Enclosed for your review is a copy of the "Draft Interim Measure/Interim Remedial Action (IM/IRA) and Closure Plan for the Present Landfill", dated August 6, 2002. Your agency's previous comments were incorporated in this draft and/or addressed by the enclosed responses. The public comment period for this IM/IRA is forty-five (45) days and ends on September 19, 2002. Please contact me at (303) 966-5918 or Scott R. Surovchak at (303) 966-3551 if you should have any questions or comments.

Interim Measure/ Interim Remedial
Action (IM/IRA)
Decision Document and Closure Plan
for the Present Landfill
at the
Rocky Flats Environmental Technology Site
Golden, CO 80403-8200

Draft
August 6, 2002

Figure 3. RCRA Groundwater Monitoring Decision Tree

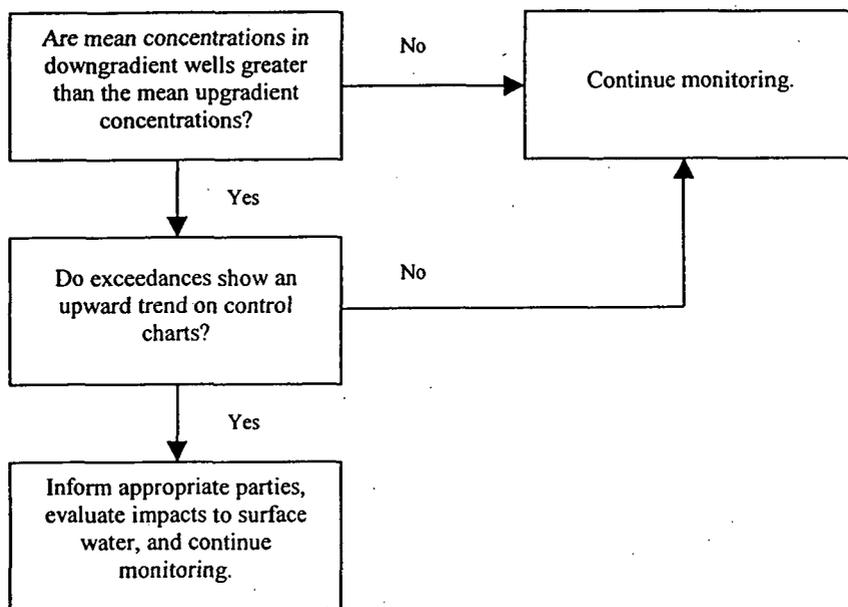
10	<p>Section 5.2.1, Page 36. This section discusses groundwater monitoring. The first sentence of the second paragraph states one upgradient and three downgradient wells will be required for post-closure groundwater monitoring. This sentence should be revised to indicate that this is a minimum requirement, that additional wells may be required, and that the final monitoring plan will show the well locations and provide a rationale for the selection of all wells in the monitoring plan.</p>	<p>Section 5.2.1 of the IM/IRA includes the following statement, "At a minimum, three wells will be placed downgradient, on the east side of the landfill, and one well will be placed upgradient, on the west side of the landfill." The document has been clarified throughout to indicate that the wells are a minimum requirement.</p>
11	<p>Section 5.2.1, Page 38. This section discusses groundwater monitoring. The IF query in the decision statement on page 38 indicates that the mean concentrations in any downgradient well must exceed the concentration in the upgradient well by more than two standard deviations of the data set before a report is made to the appropriate agencies. The agencies should be notified whenever the mean concentration in the downgradient well exceeds the mean concentration in the upgradient well. The phrase by more than two standard deviations of the data set should be deleted.</p> <p>The decision statement also indicates no action other than continue monitoring. The decision statement should indicate scenarios and criteria that will trigger actions other than monitoring, and specify what those actions will be.</p>	<p>This section is consistent with the Integrated Monitoring Plan methodology for monitoring, reporting, and decision making. The IMP is currently used for the RCRA monitoring around the Present Landfill and its methodology was developed using the consultative process with DOE, CDPHE, EPA, K-H, and the stakeholders.</p>

Cmt. #	Comment	Response
22	<p><u>Section 5.2.1</u> – The post-closure care requirements in Part 365.310 refer to the groundwater monitoring requirements in Part 265, Subpart F. As stated, the groundwater monitoring wells “will be used primarily to determine if contaminants that have the potential to impact surface water are leaching from the landfill.” This is not consistent with the statement that “compliance will be based on generally declining contamination levels.”</p> <p>Since groundwater flows toward the landfill from 3 directions, at least 3 up gradient monitoring wells are needed. Because of the size and topography of the downgradient area, more than 3 wells will probably be needed to provide coverage for downgradient monitoring.</p> <p>Water quality analytes should include radionuclides, metals and VOCs. A better evaluation needs to be done to understand if water quality parameters already showing problems (sodium, chloride, and sulfate) will be improved by this remedy or if alternate concentration limits will be needed.</p> <p>Groundwater monitoring DQOs need to be refined for each monitoring situation; some wells will require quarterly monitoring, others may not. Groundwater level monitoring will be needed within the landfill to document the effectiveness of the cover and/or ground water remedy.</p> <p>The statement that “groundwater is not discharged to surface water in No Name Gulch” is inaccurate. This is supported by discussion in Section 2.4.2 and 2.5 that groundwater contributes to the landfill pond which is in the headwaters of No Name Gulch. Further, Section 2.4.2 discusses “groundwater seepage past the dam, into the lower drainage, flows eastward along the stream course until it is discharged via ET, surface water, or as lateral subsurface flow at Indiana.” Other documents identify that subsurface flow at Indiana is minimal. Even though the end of Section 2.5.2 indicates that “no groundwater seeps have been observed to flow into No Name Gulch below the East Landfill Pond”, does not mean that there is no groundwater discharge to No Name Gulch, especially if the landfill pond is removed, then there would be direct groundwater discharge to No Name Gulch.</p>	<p>The wording in the IM/IRA is from RFCA, Attachment 10, I.C. “At the POCs, compliance would be based on: 2. generally declining contamination levels for units/areas with pre-existing groundwater contamination levels greater than the ACLs (this assumes placement of a DCL cap/cover is in place).”</p> <p>Section 5.2.1 of the IM/IRA includes the following statement, “At a minimum, three wells will be placed downgradient, on the east side of the landfill, and one well will be placed upgradient, on the west side of the landfill.”</p> <p>As indicated in Section 1.0, “...while the landfill cover design is being completed, the operability of the existing groundwater interceptor system will be investigated and groundwater data will be analyzed to determine whether a groundwater accelerated action is needed. If such an action is required, this IM/IRA will be modified in accordance with Part 10 of RFCA.”</p> <p>The DQOs were taken from the IMP and can be revised, once the groundwater evaluation is complete.</p> <p>The sentence including, “groundwater is not discharged to surface water in No Name Gulch” has been removed.</p>
